**ADDENDUM
NO. 2**

August 23, 2021

**SCHOOL CITY OF HAMMOND -
2021 RENOVATIONS TO MORTON HIGH SCHOOL
AND SCOTT MIDDLE SCHOOL
Hammond, IN 46320**

FIRST FLOOR PLAN - UNIT A
 AF1A1

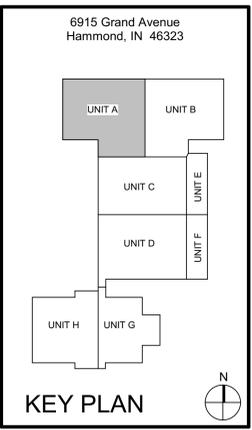
8. Morton HS: Filling 112A shows a door frame to be removed (AD1A1), later to be infilled (AF1A1), but shows no Plan Note. What is this to be infilled with? Response: See Addendum #2, AF1A1.

9. Morton HS: AD1A1 shows a section of wall to be removed near door112A, for what looks to be a new door, but AF1A1 shows nothing in that area. Please clarify. Response: See Addendum #2, AF1A1.

G-003

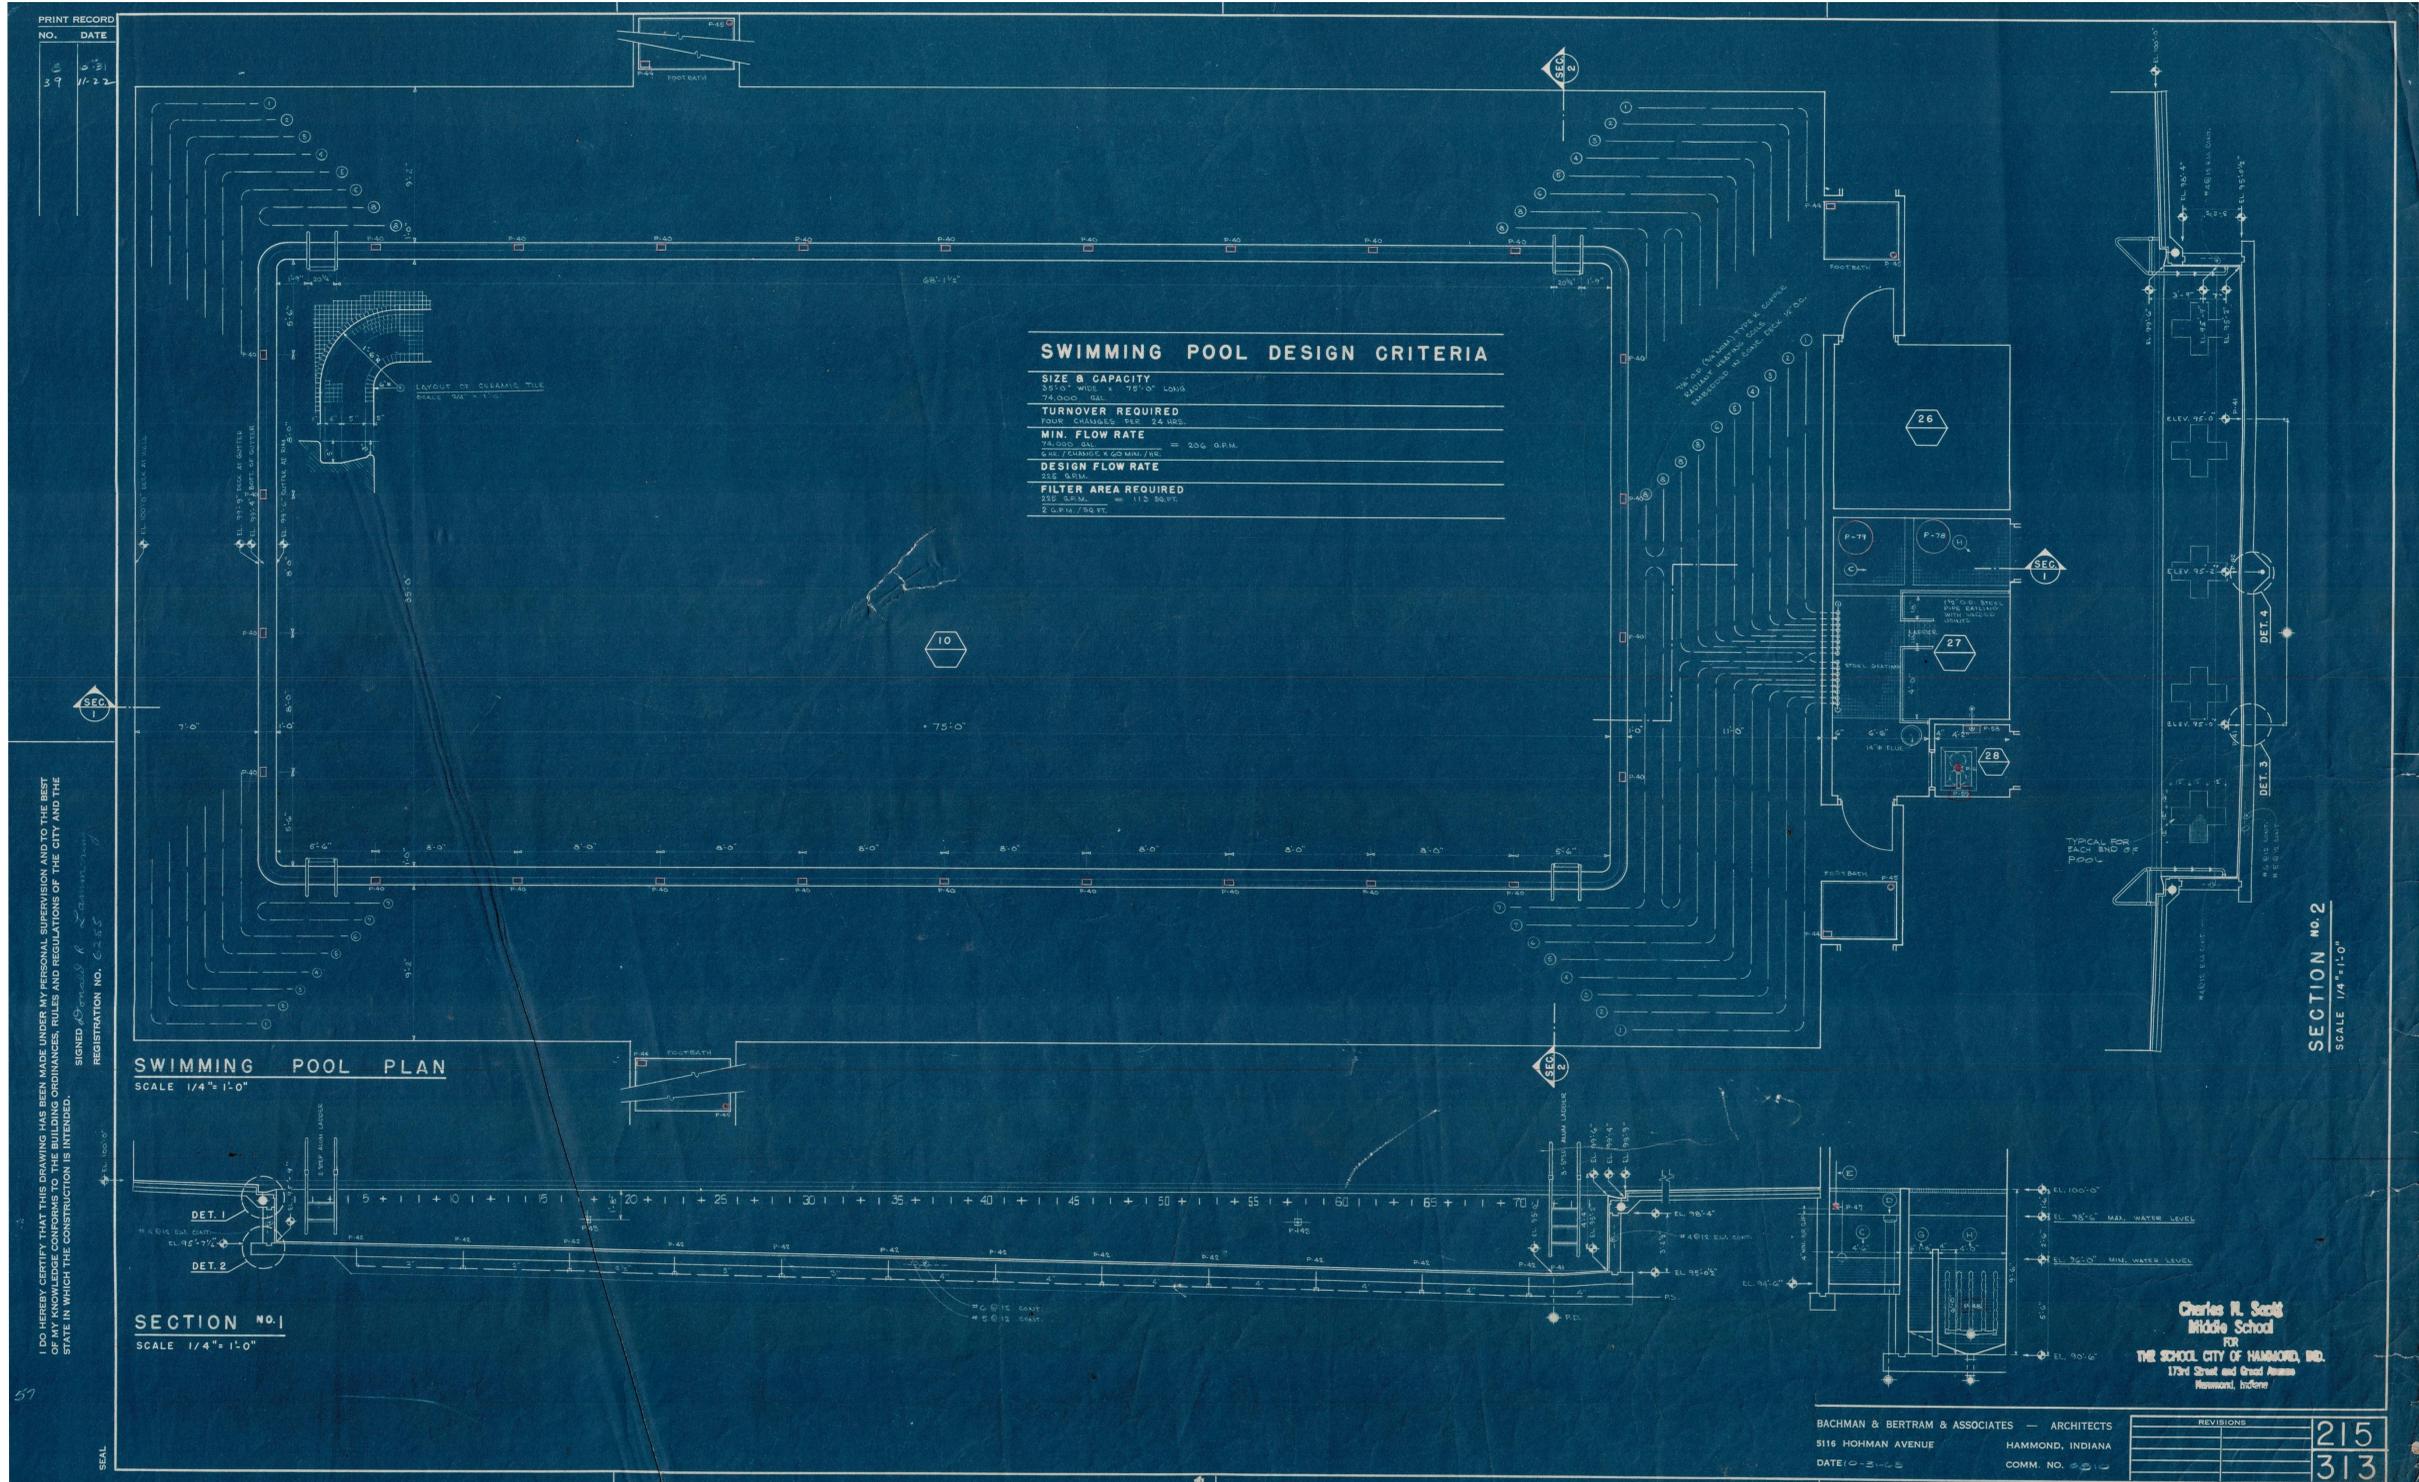
1. can you clarify if the ductwork gets liner or wrap? Calls out both in the spec Response:
Externally Wrapped
2. Scott MS: I can't find the depth of the existing pool to determine how much granular fill is required. Response: See Addendum #2. The existing drawings of the swimming pool has been provide for reference only.

1A TEMPORARY CLASSROOM PLAN
 1/8" = 1'-0"

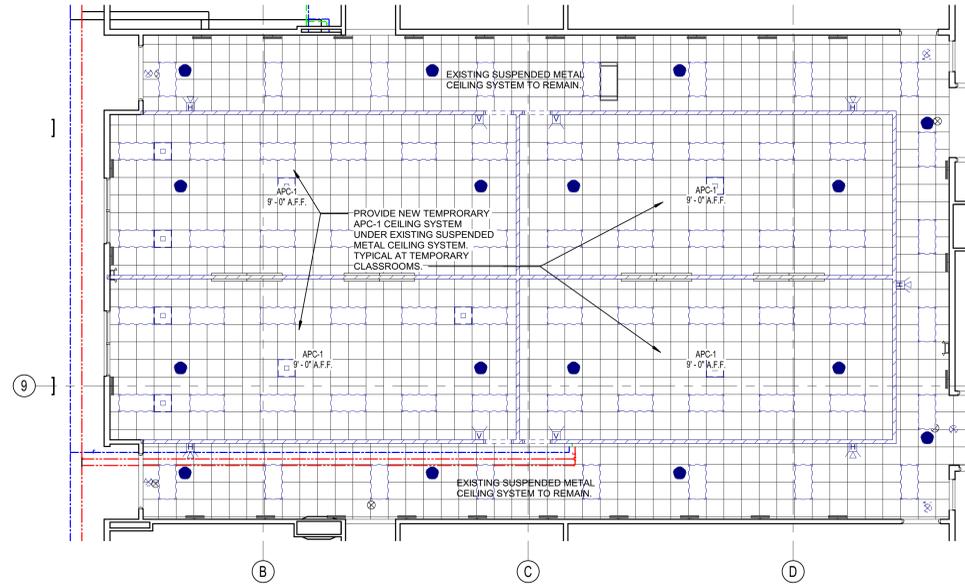
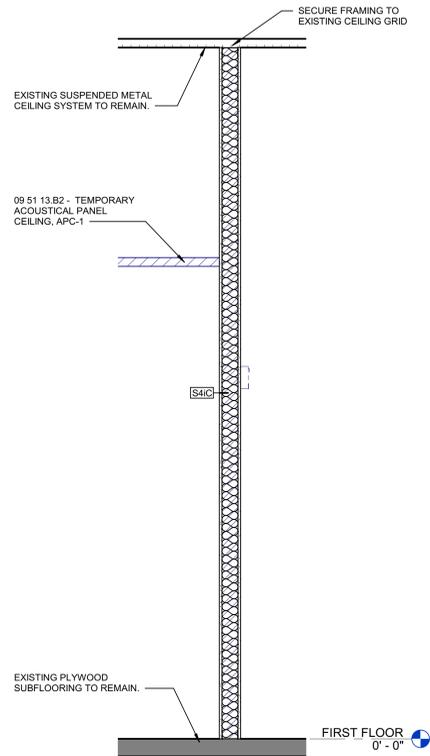
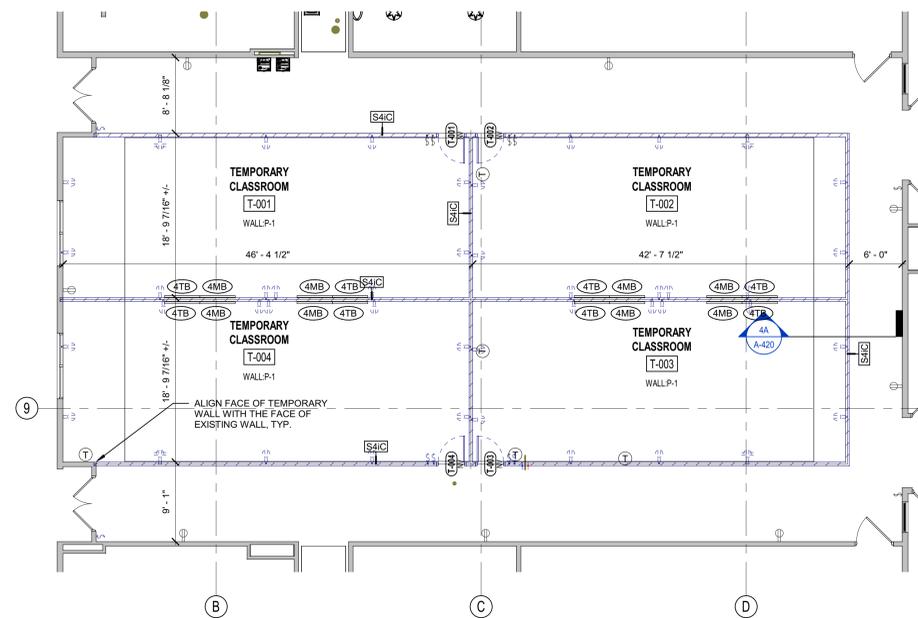
Regarding sheet A-420 Scott Middle School, the **Bid Category No. 6 Contractor** shall provide temporary power and lighting within the temporary classrooms starting on September 15, 2021 until June 30, 2022.

FIRST FLOOR LIGHTING PLAN - UNIT D

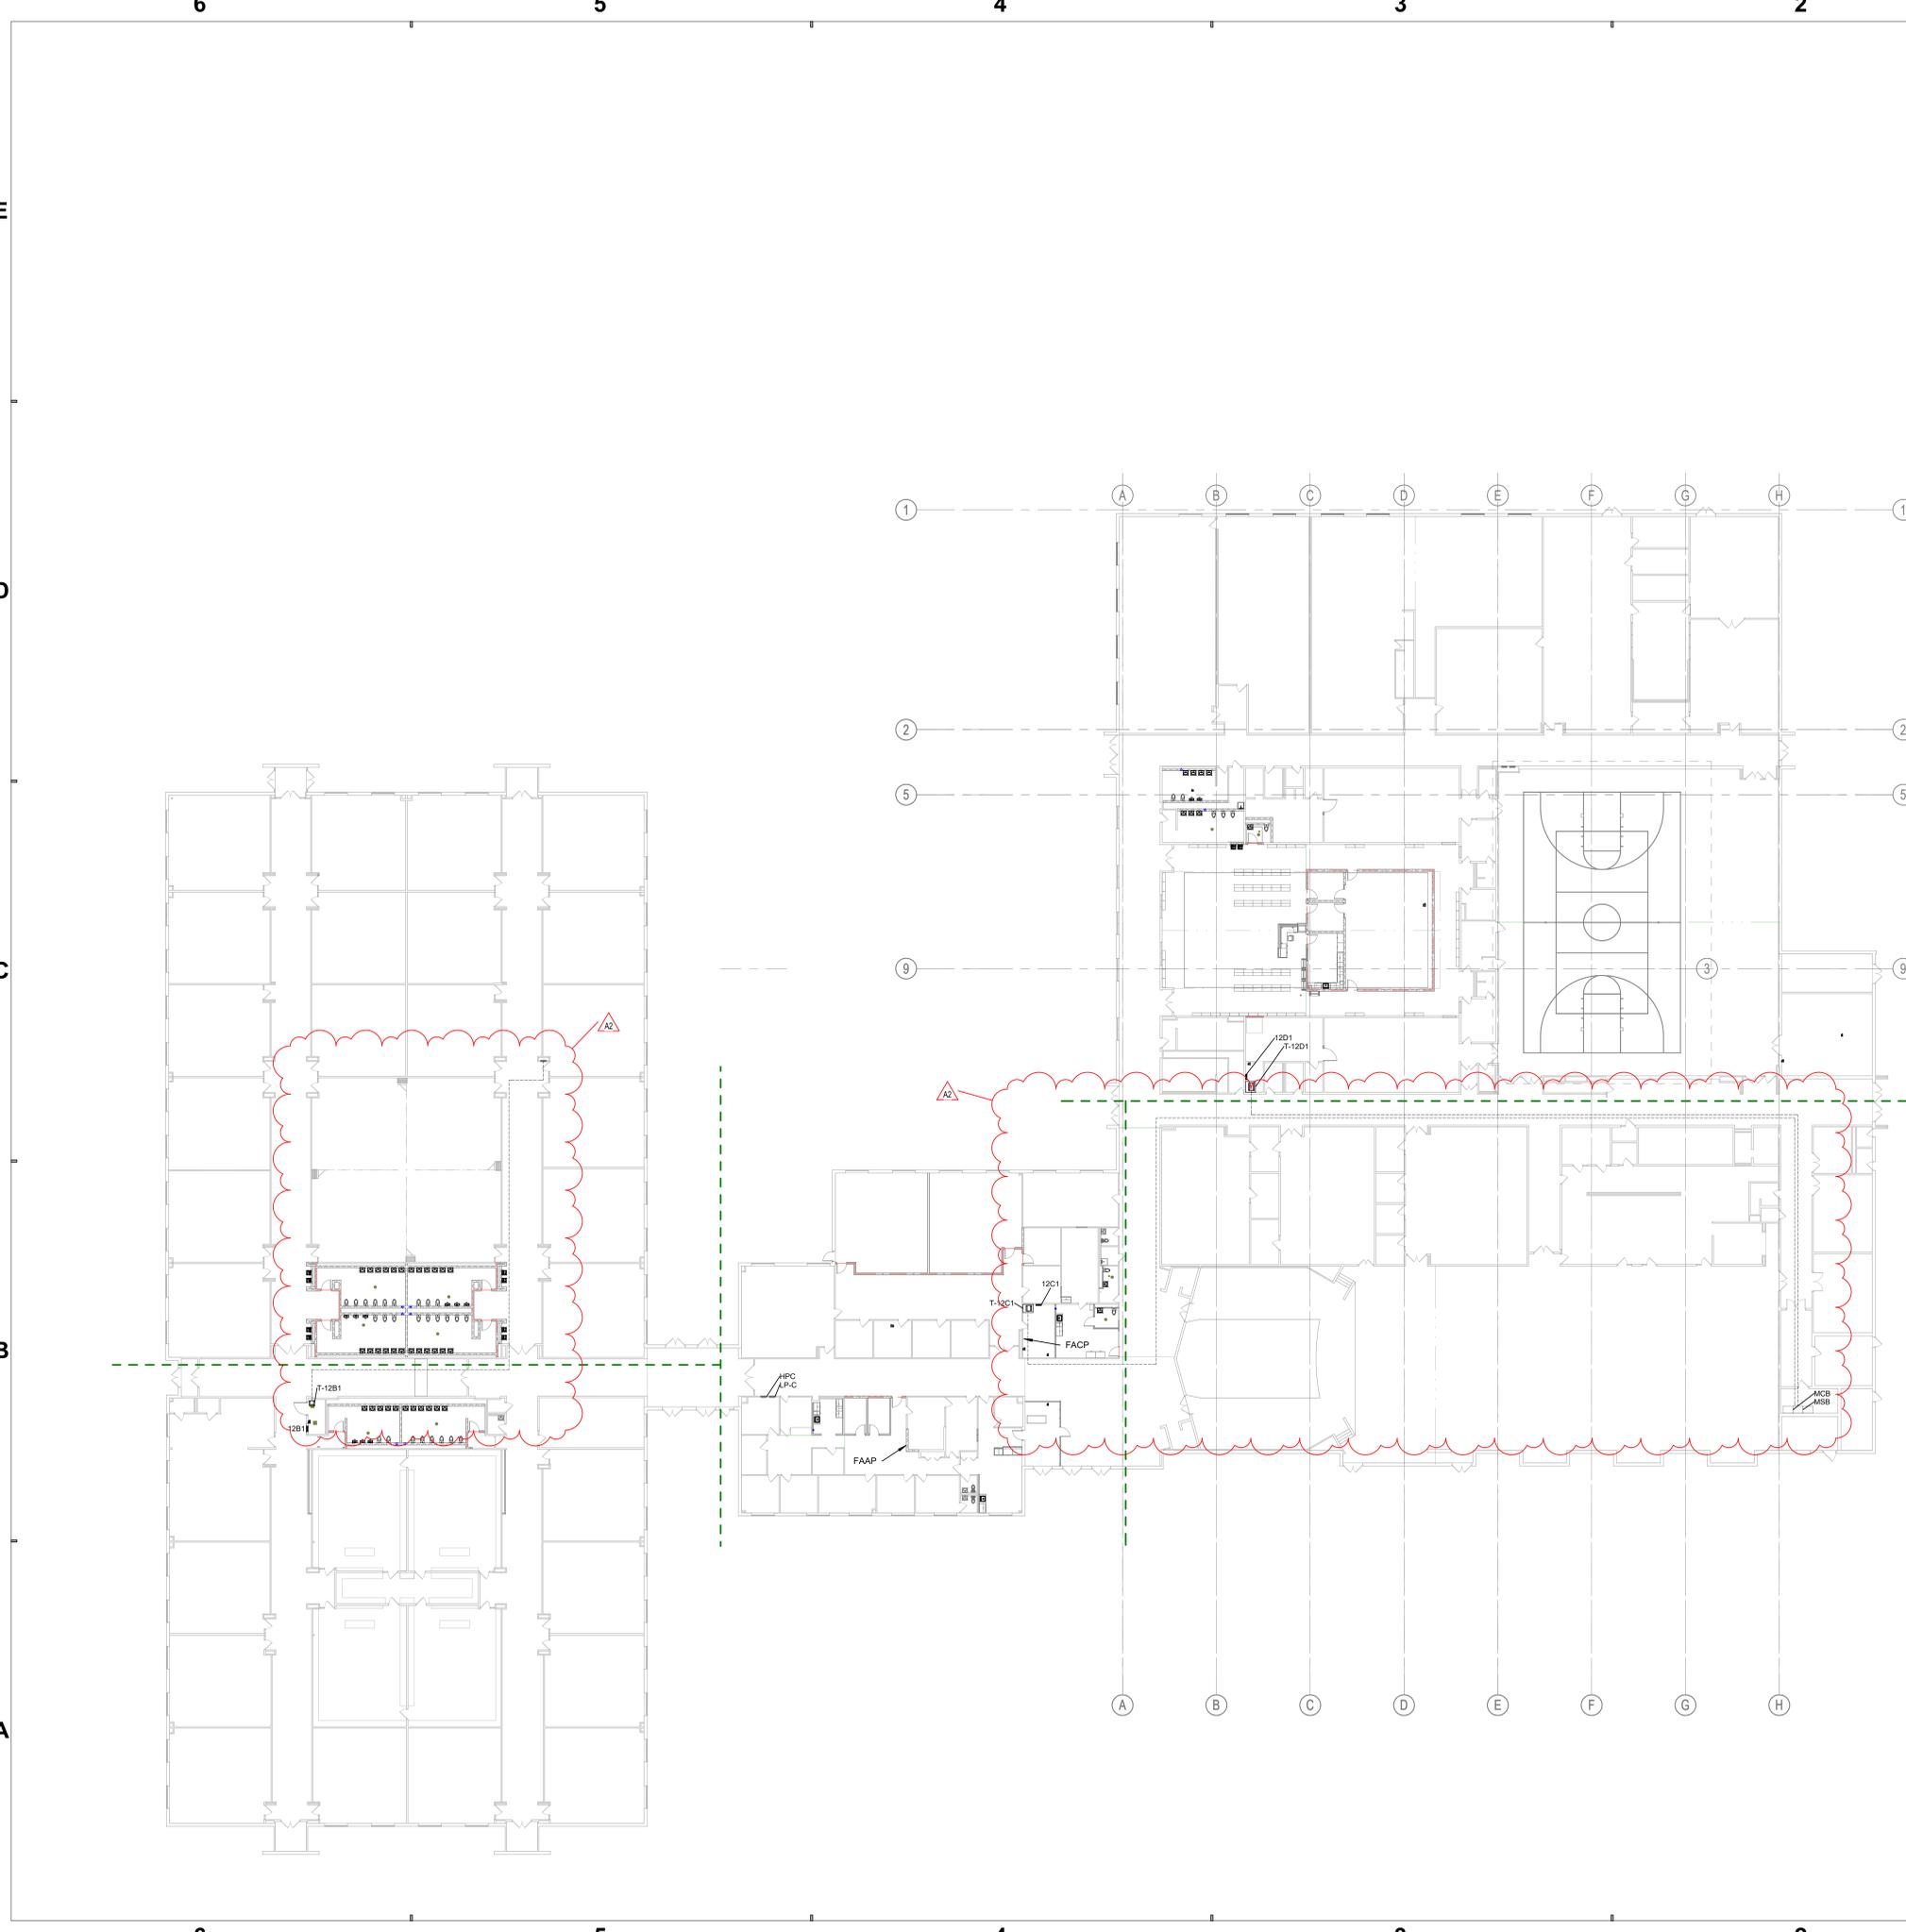
15. Scott MS: Sheet EL1D1 shows EM fixtures fed from lighting inverter MI-D1, however, MI-D1's location isn't shown nor is it listed on the Central Battery Equipment schedule on Sheet E-602. Please advise. Response: See Addendum #2.
